FINAL - Meeting Summary Notes
Lewis River License Implementation
Merwin Trap Engineering Subgroup
March 7, 2006
Merwin Hydro Facility, Ariel, WA

Sketch 1: Sorting Process for September

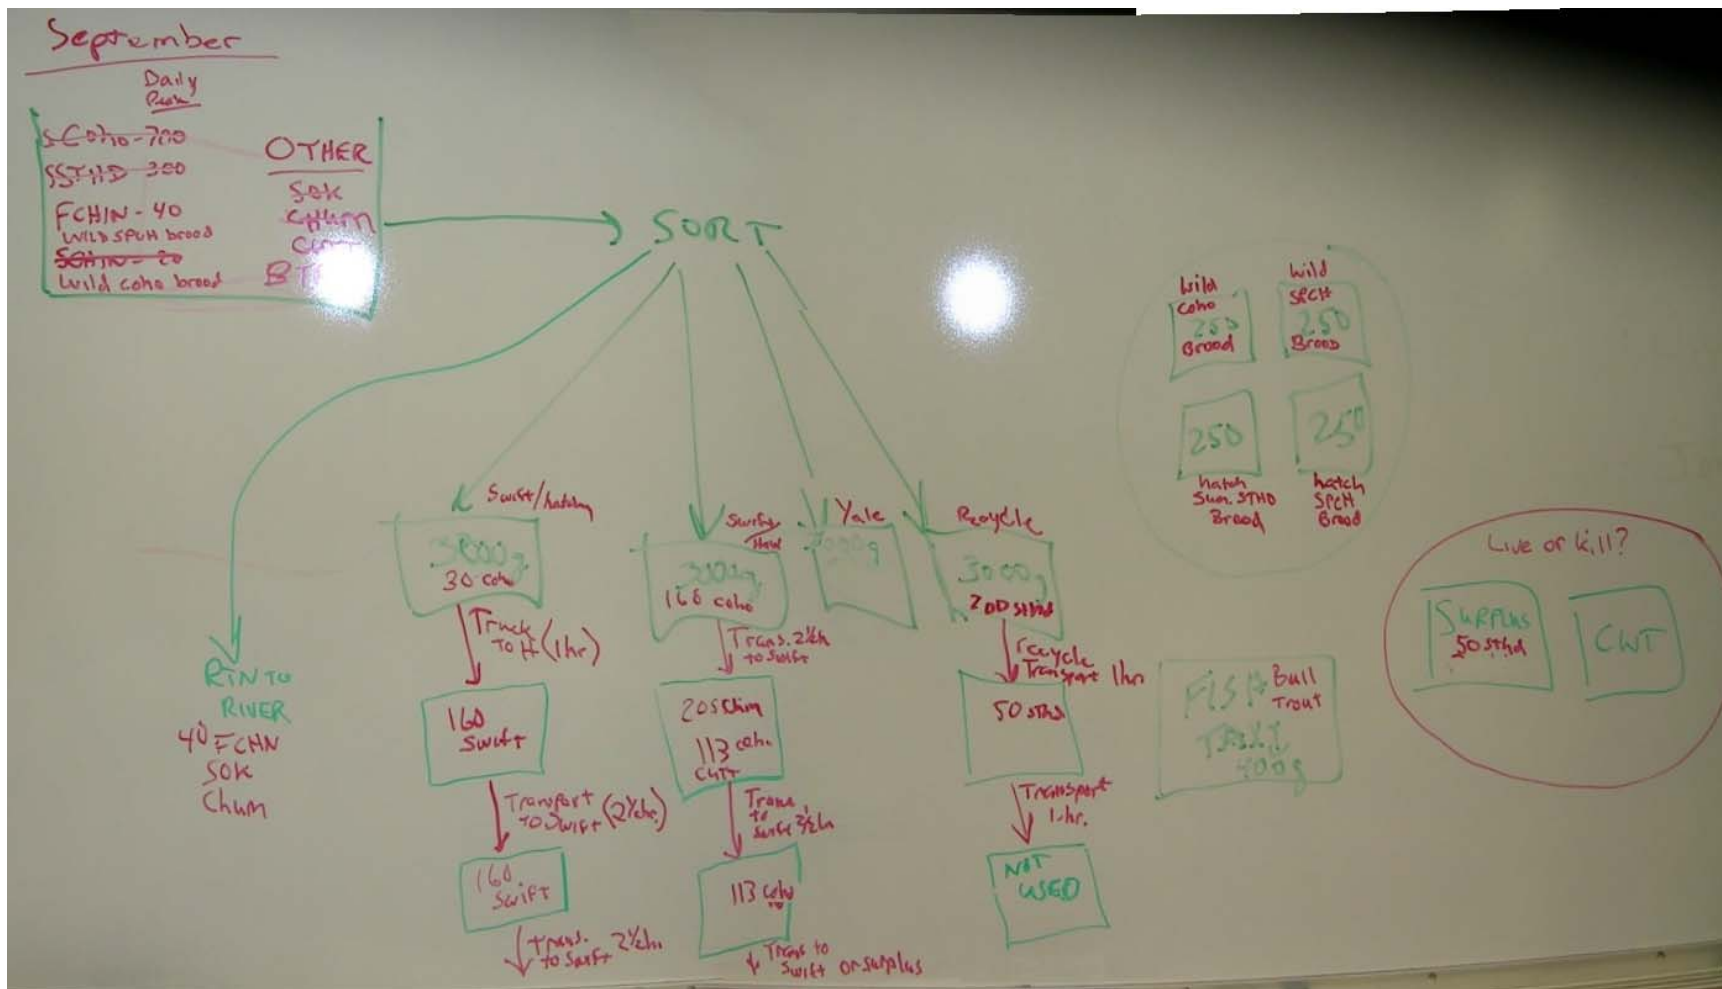
Frank Shrier drew a sketch that outlined the entire sorting process for the limiting month of September, as it is envisioned on the spreadsheets in the criteria documents. Up to 1,500 fish may need to be handled in a single day (say 6 hours). The sketch is included on the next page as Sketch 1.

After the group worked through the development of the diagram above, it was apparent that the last remaining issue is to agree upon a fish surplus protocol: specifically, whether the surplus process should be performed at the Merwin Trap, or at Lewis River Hatchery. This decision will have impacts on either facility, as the surplus station will require killing fish, kill fluid collection and treatment facilities, and organization of holding and cold storage for the fish (for up to one day) for buyers.

There was a long and interactive discussion regarding the number of fish to design to, staffing needs, number of trucks, tank and tote needs, impacts to the surplus station facilities, and some detail on how the surplus station will actually function. The group agreed that the facility should be designed to accommodate 2,000 fish per day in September. The design of the surplus station will need further development, but it is clear that a coded wire tag reader will be needed, and surplus fish will be placed on one of two totes:

- Live haul surplus fish or kill at Merwin trap and transport via totes to Lewis River Hatchery. Agree on where the surplus station facilities should be located (Merwin Trap or Lewis River Hatchery).
- Define a handling protocol for the surplus fish.
Discuss whether an additional large tank or fish truck is required.
- Agree on the 50 to 100 fish/day maximum surplus number.
